ADDENDUM # 2

Reference: Security Fencing – Olympus and Timpanagos Facility
Draper Prison – Department of Corrections
DFCM Project No. 05082100

Subject: **Addendum No. 2**

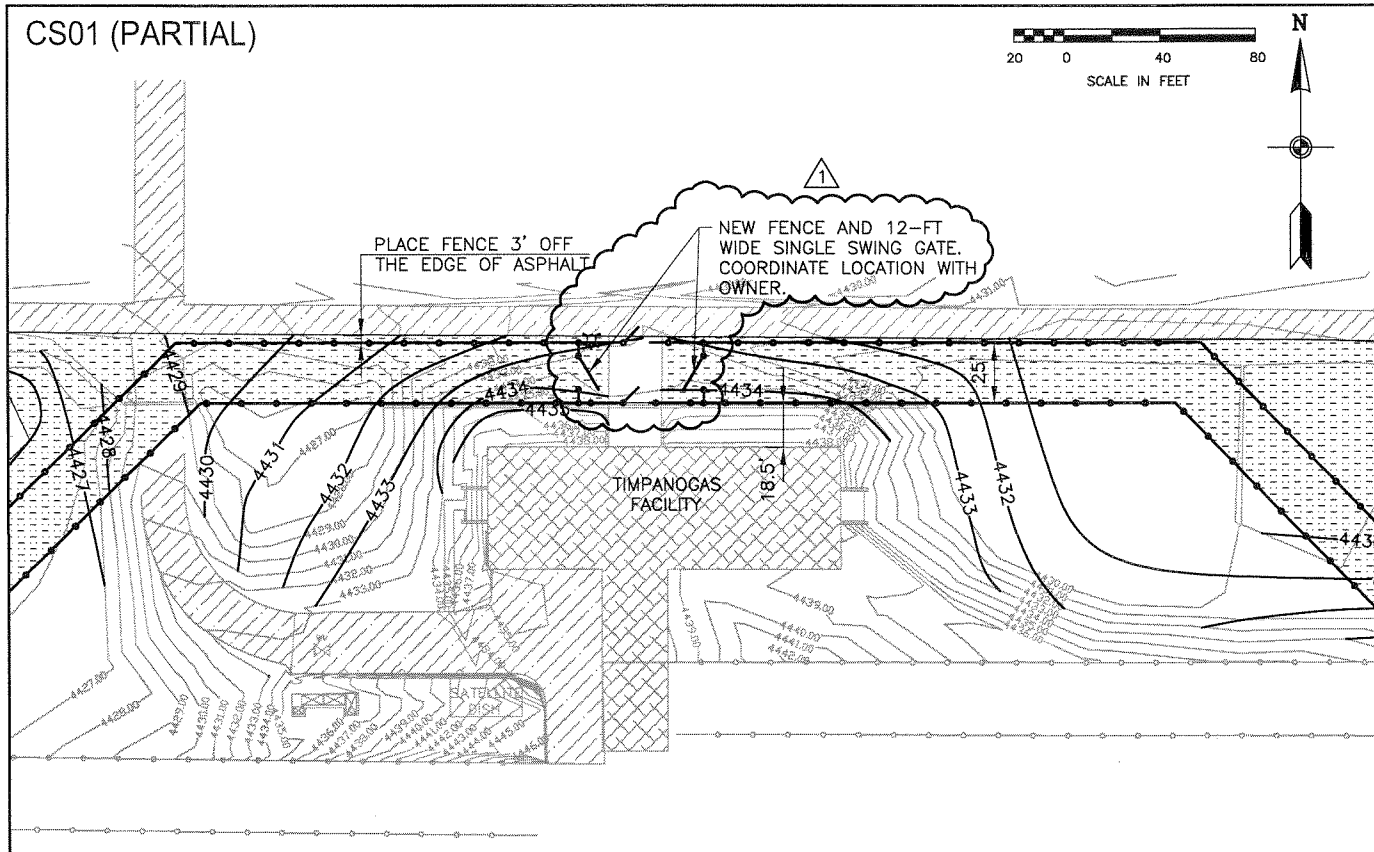
3. **Question:** Drawing D02 (sheet 8 of 8) has a very clear detail for the steel frame work required for magnates. However, there is no detail of the gate itself. Is the intent to put a chain link gate in the framework shown, or some other type of door? If it is to be a chain link gate we will need a detail of the gate construction, especially the hinge design and locking mechanisms.

Answer: For the man gates, the Owner will supply the gate and the contractor shall install the gate in the steel frame work. The 12' single swing gates will not be installed in steel frame work and shall be supplied and installed by the Contractor.

Figure 1
ADDENDUM NO. 2

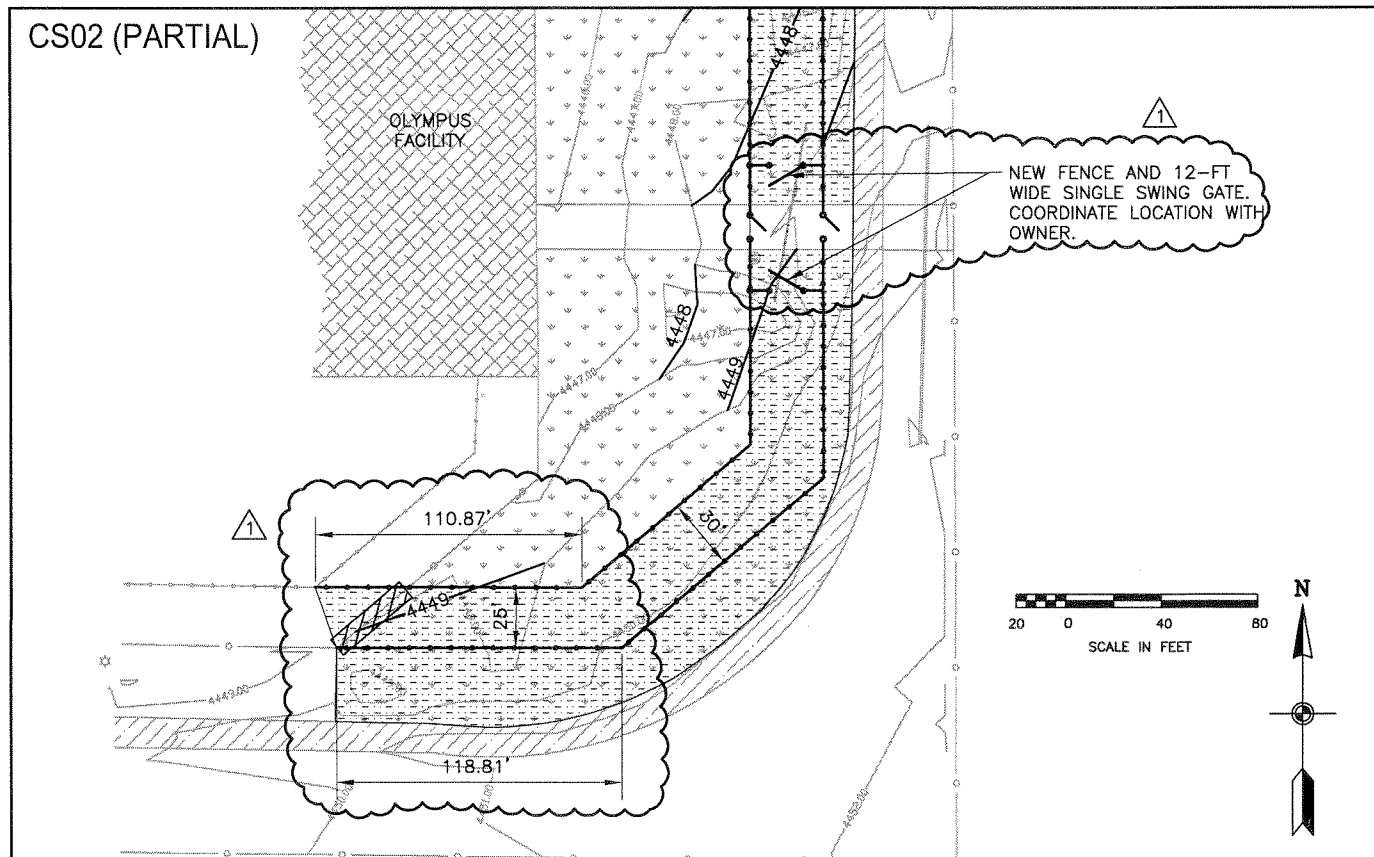
5. **Drawings:** Add 12' wide swing gates to drawings CS01 and CS02 according to the attached Figure 1.

△ SWING GATES, AND DIMENSION UPDATES
